INFORMATION REGARDING ENVIRONMENTAL AUDIT REPORTS

The environmental auditor is of the opinion that the assessment methodologies of the reports prepared by the assessors was adequate for the purpose of this audit and confirm that the assessments were undertaken in accordance with applicable EPA Victorian guidelines, in particular the Landfill BPEM, as well as EPA Publication 1642 Assessing planning proposals within the buffer of a landfill. The table below summarises the auditor's findings:

Paul Fridell of Environmental Resources Management Australia Pty Ltd (ERM) was engaged in his capacity as an Environmental Auditor (*a person appointed as an Environmental Auditor, pursuant to the Environment Protection Act 1970*) to conduct a voluntary environmental audit of risk of possible harm or detriment to the land, noise and air environment within 500 metres of the Eaglehawk landfill (the site) located at 191-193 Upper California Gully Road, Eaglehawk (refer to *Figure 1, Appendix A* for a site locality plan). The audit was conducted in accordance with Section 53V of the *Environment Protection Act 1970*.

Figure 8.1 Control Areas (AECOM, 2019)

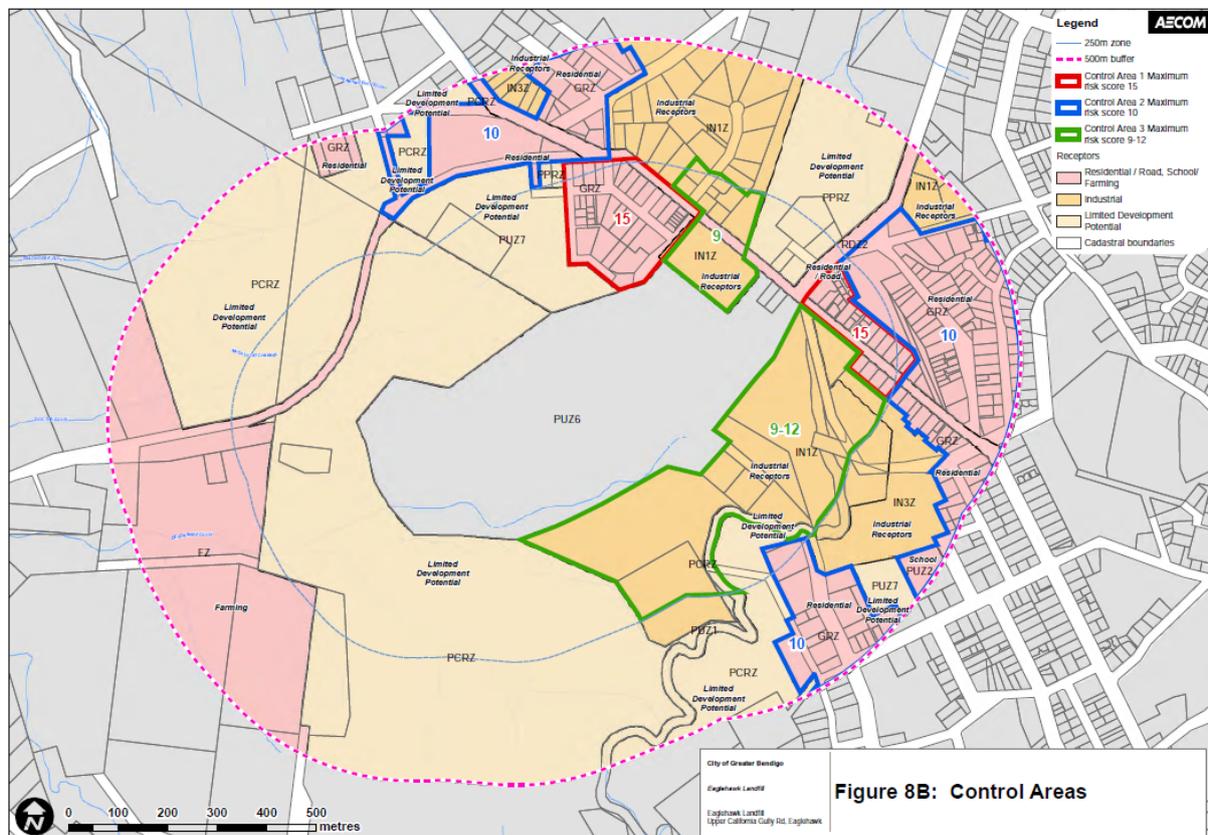
Control areas, which provide the basis for planning controls, have been designated where the risk scores are greater than 6 and according to the CS status, that is CS2 within 250 metre band and CS1 within 250-500 m band. These are presented in Table 16 of the AECOM report (duplicated below) and mapped in Figures F8A and F8B (Appendix A) of the AECOM report, Figure F8B also duplicated below.

The AECOM (2019) assessment evaluated the risk of LFG migration from each landfill cell (source) to adopted receptor groups via designated pathways within the Landfill BPEM buffer. The assessed risk scores designate the management practices and control measures required (refer to *Table 8.4*) and the control areas designate the planning controls required (refer to *Table 8.7*). Three control areas were identified based on risk scores (greater than 6 and less than 15), see Figure F8A in Appendix A of the AECOM report.

Figure 8A: Control Areas

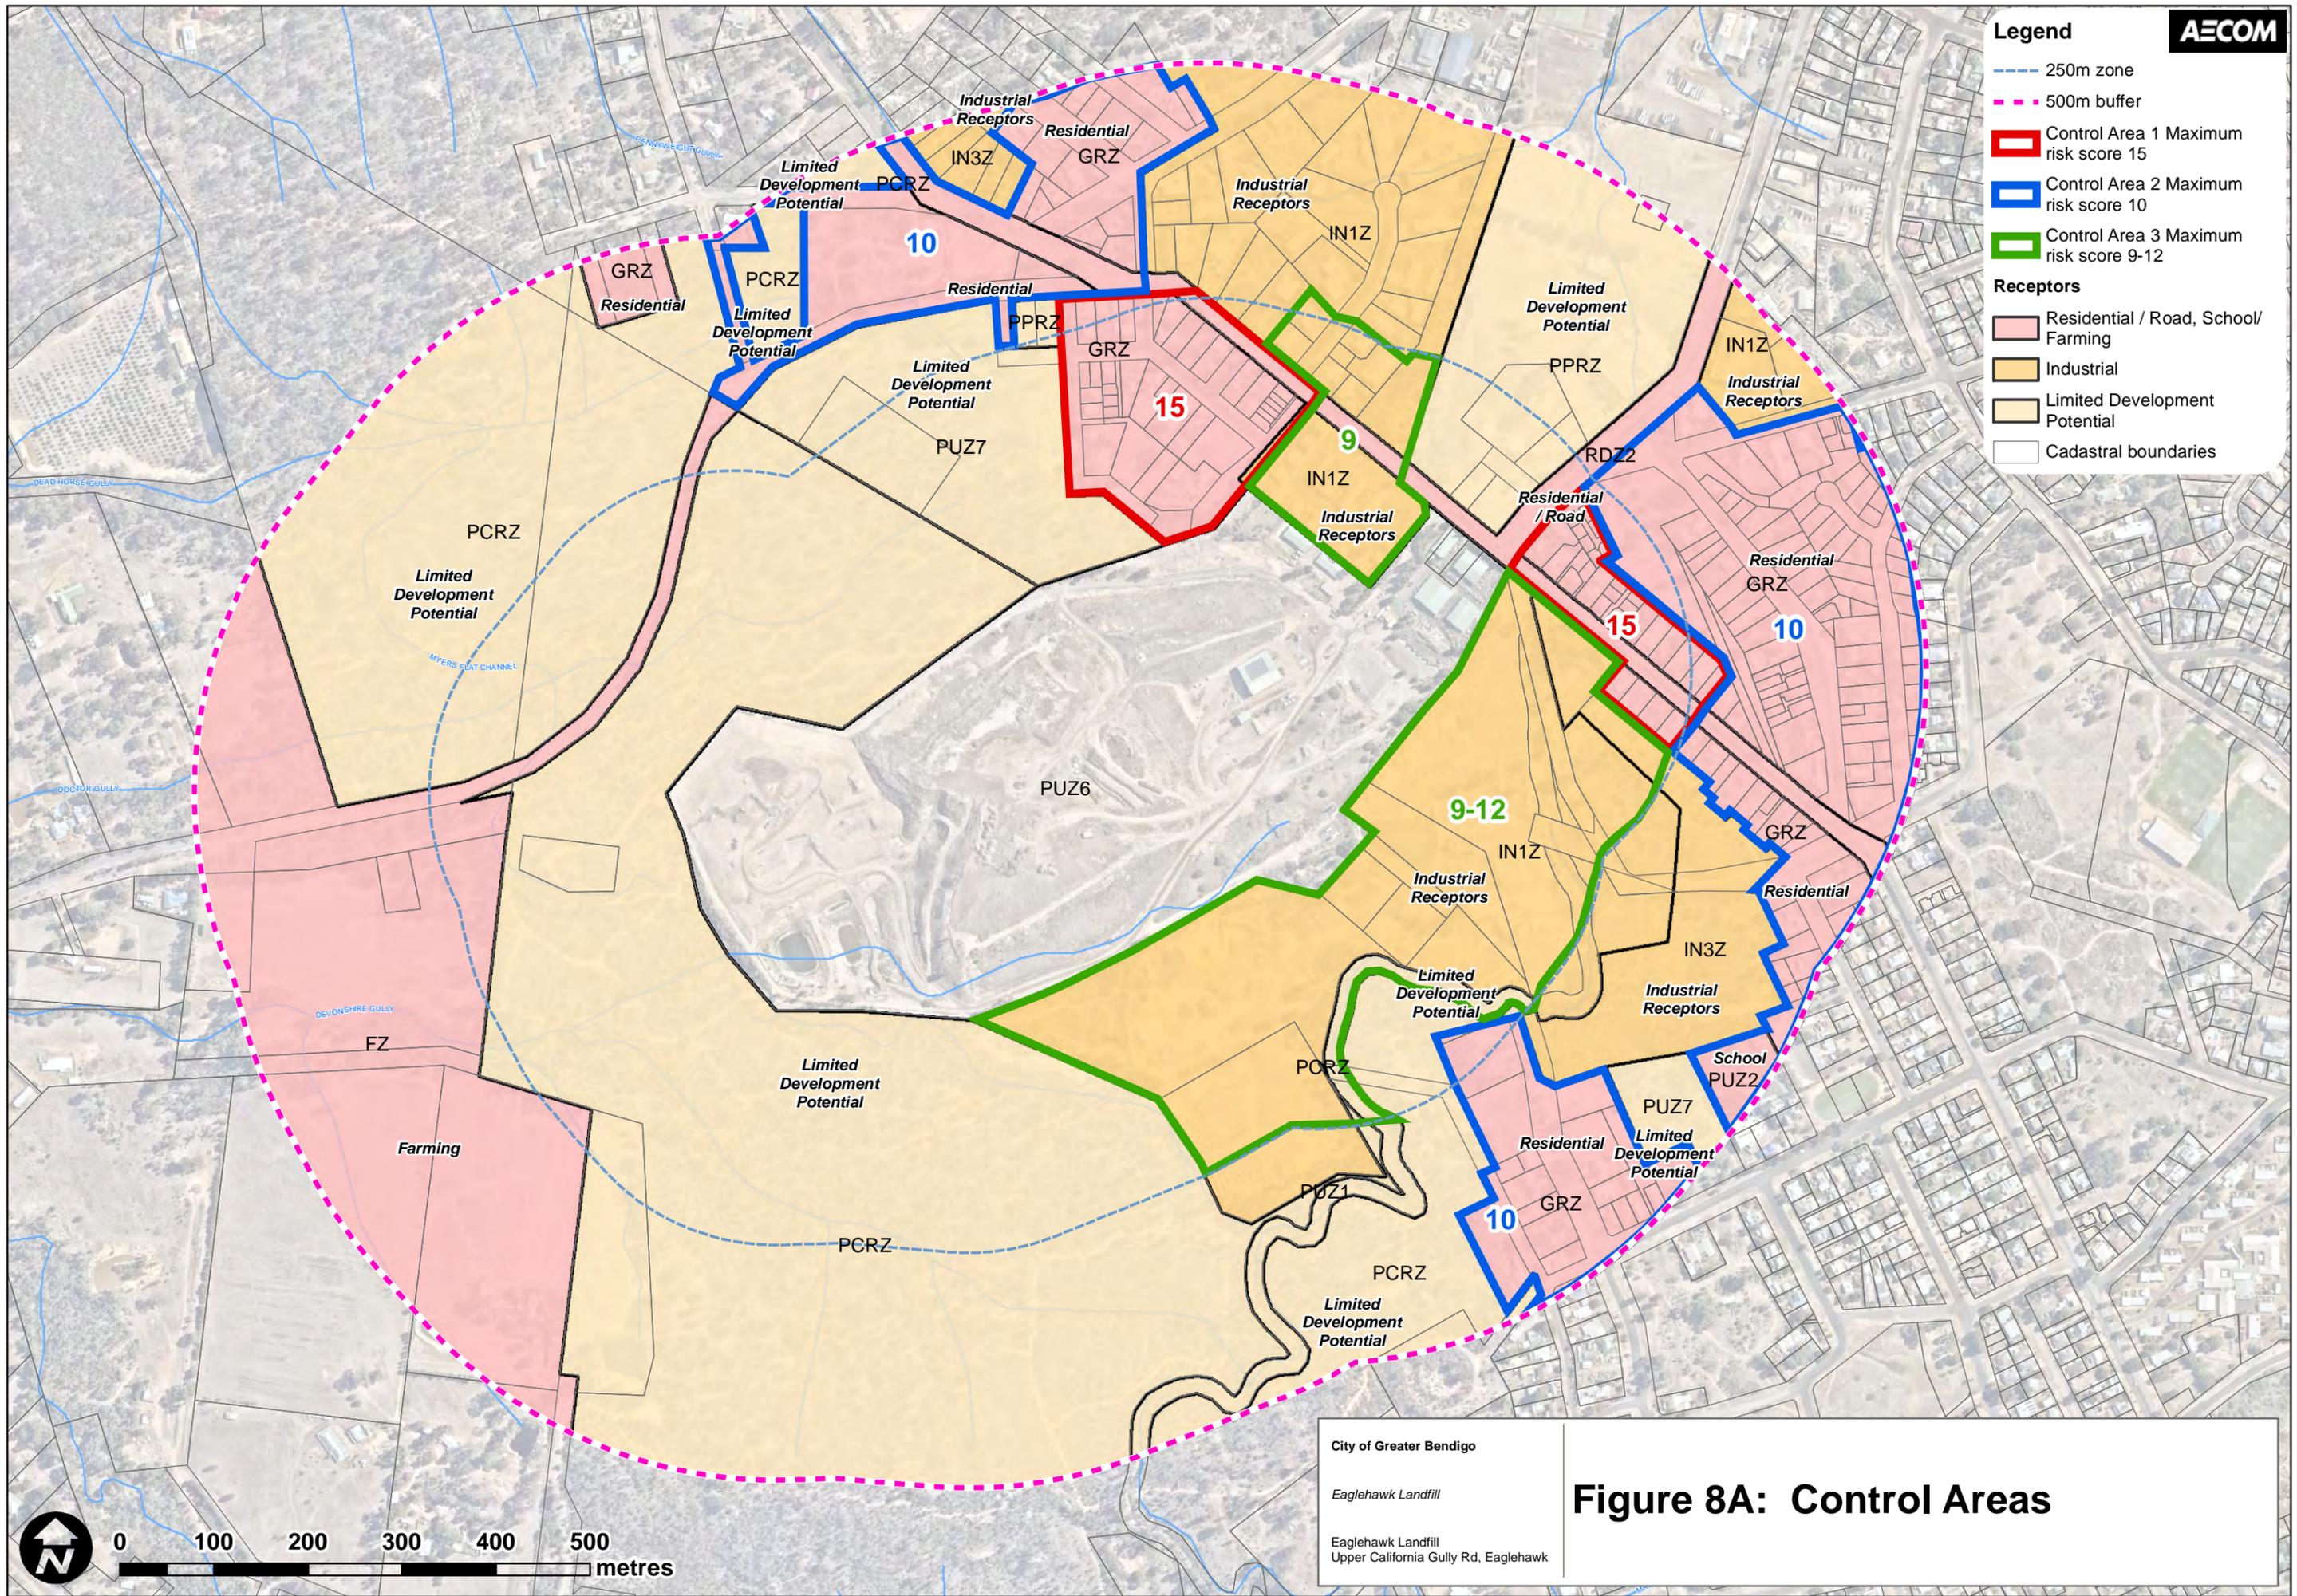
Under assumed upset conditions, the assessment of risk scores remains the same as normal operations for existing and proposed site activities. Figure 8A provides the risk scores within the Landfill BPEM buffer. The risk scores are higher closer to the landfill boundary, ie closer to the source, with the level of risk reducing as the distance to the landfill boundary increases.

AECOM do not recommend any reduction to the current Landfill BPEM buffer applying to the site, however based on an assessment of risk, has identified areas that will require management measures and planning controls with remaining areas not requiring any measures and/or controls, in order to allow for new land use and development. Refer to Figure 8A Appendix A of the AECOM report.

Figure F9: Proposed New Bore Locations

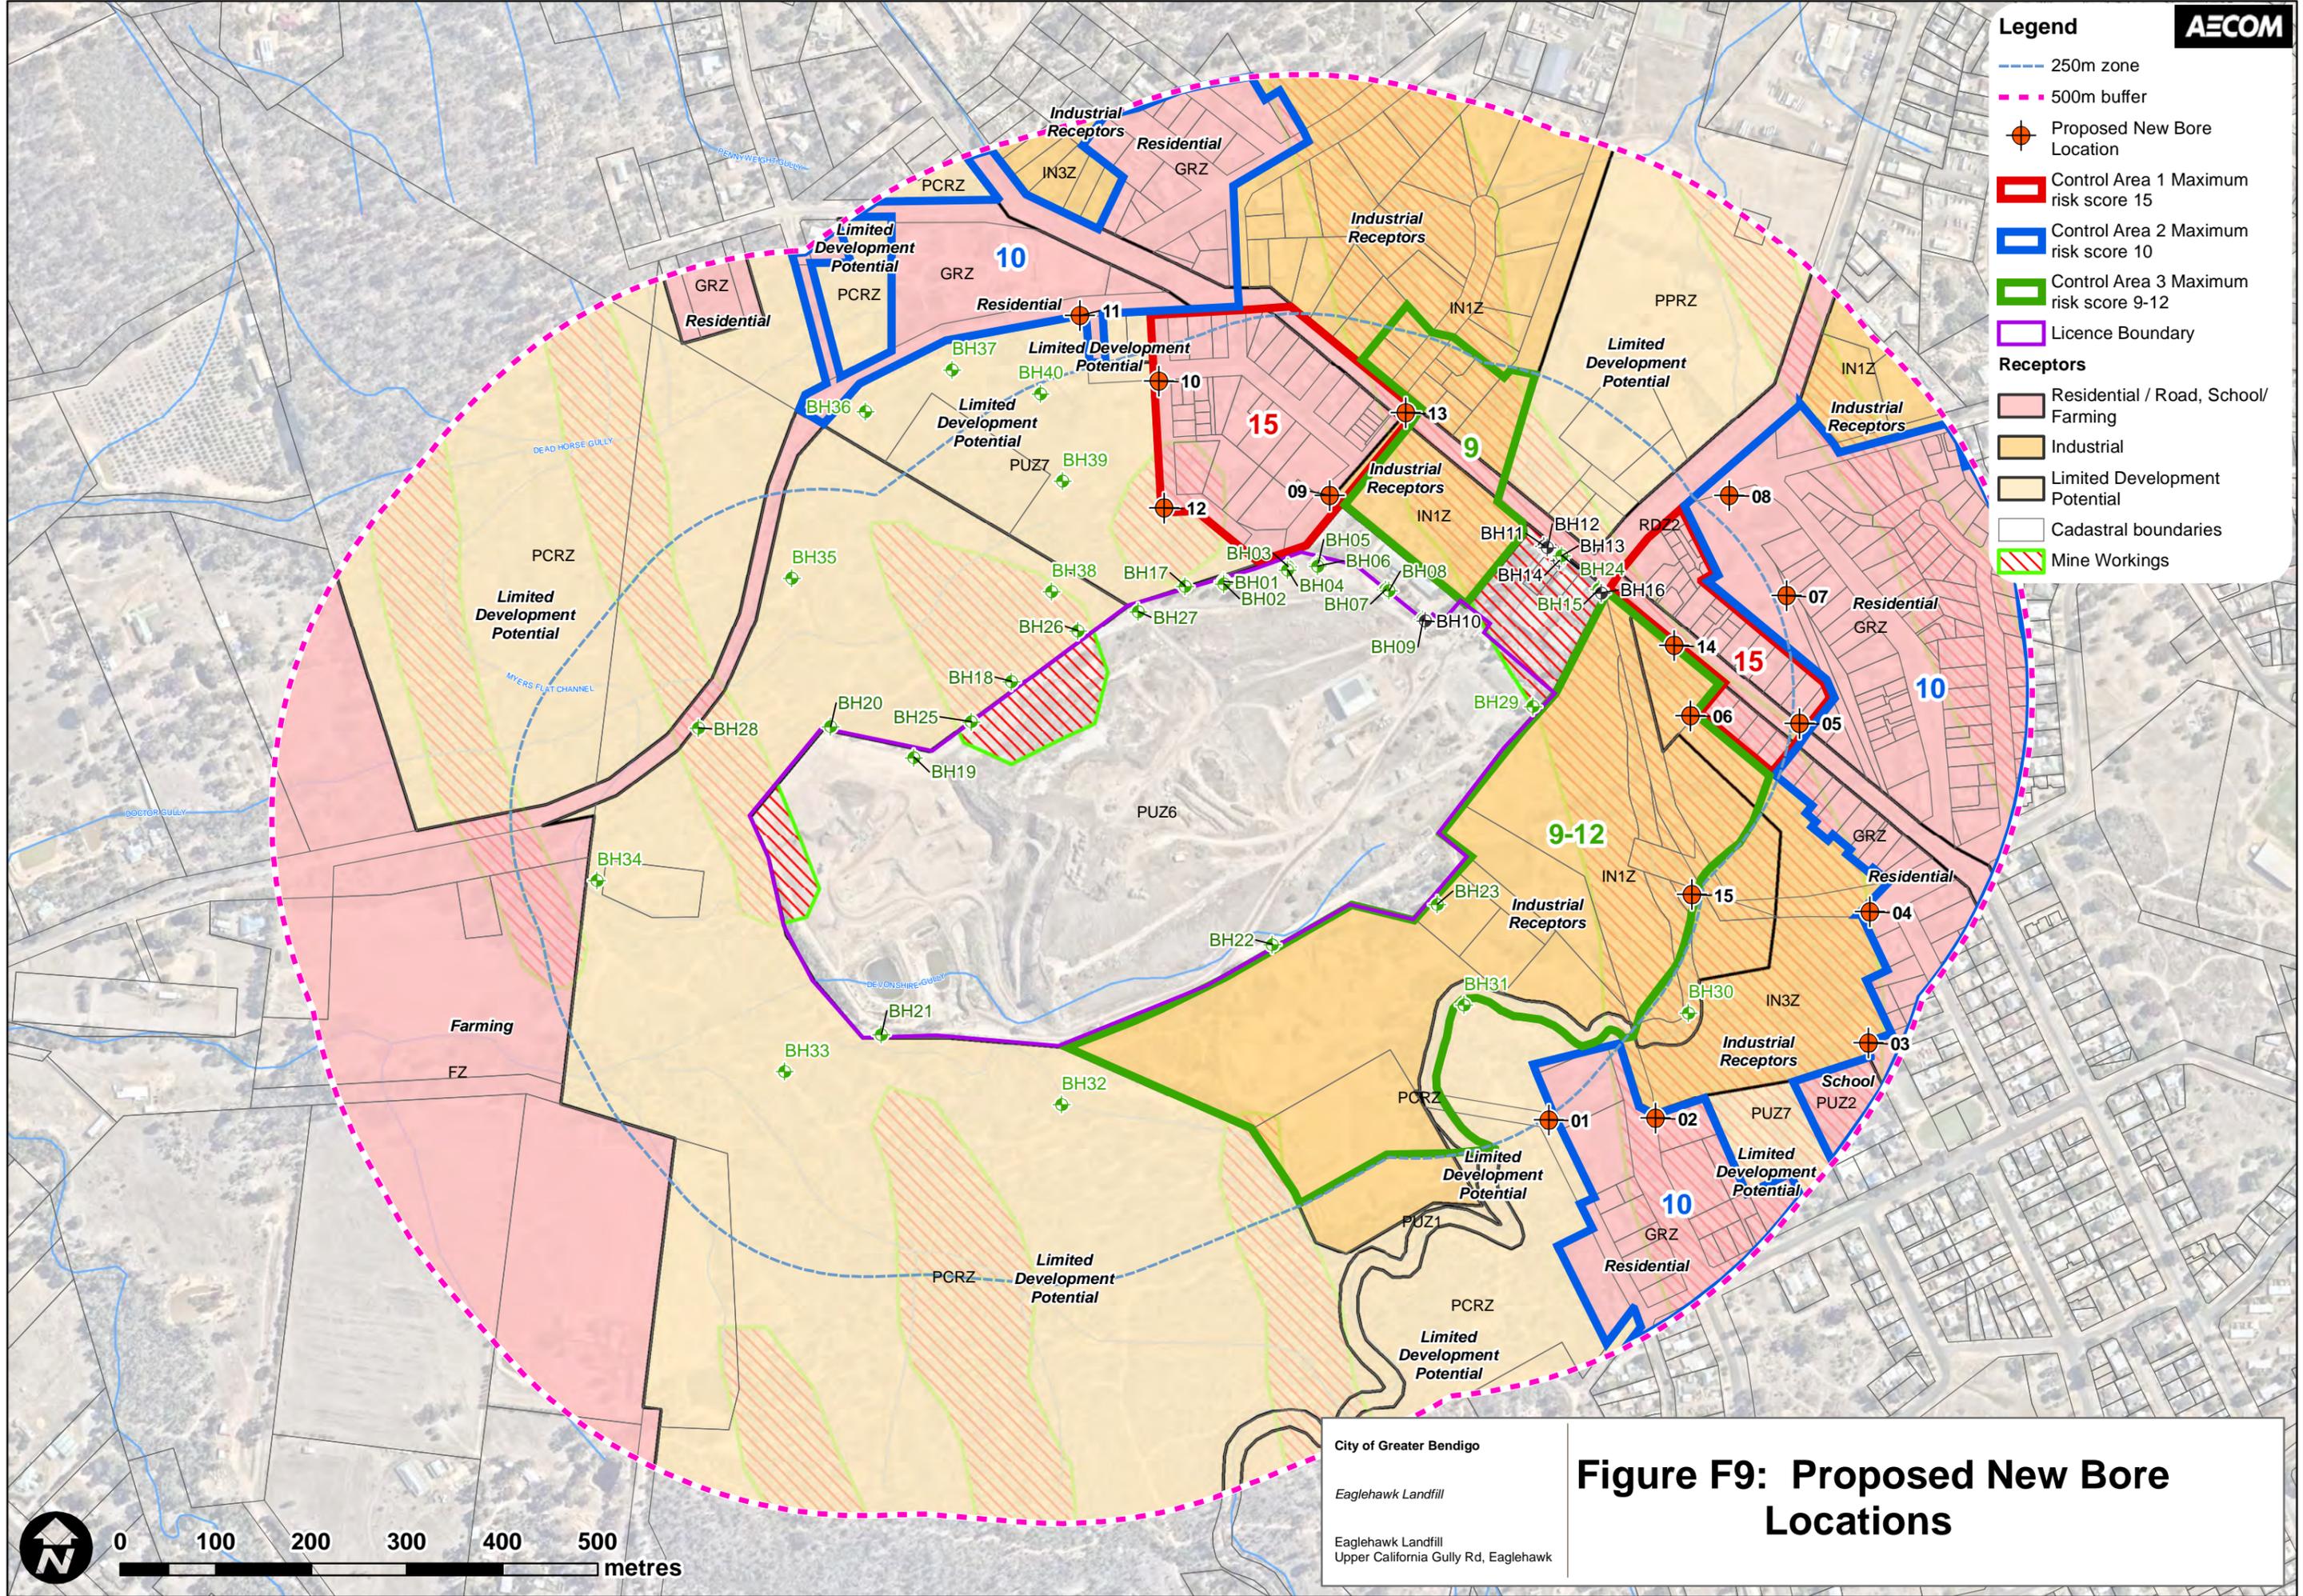
1912-R4	<p>Specifically for control area 2, it is recommended that underground services and a number of new LFG monitoring bores be installed and monitored by the City of Greater Bendigo, as per Figure F9 of the AECOM report, to provide an early warning of the migration of LFG off-site. These additional bores and monitoring requirements are to be incorporated into the next revision of the current Environmental Monitoring Program for the site and verified by an EPA appointed Environmental Auditor as required by the current licence condition LI_L1. The EMP is to include contingency actions should LFG be encountered at levels that present a greater level of risk (as determined using British Standard 8485 (as amended)) as previously assessed in control area 2.</p>
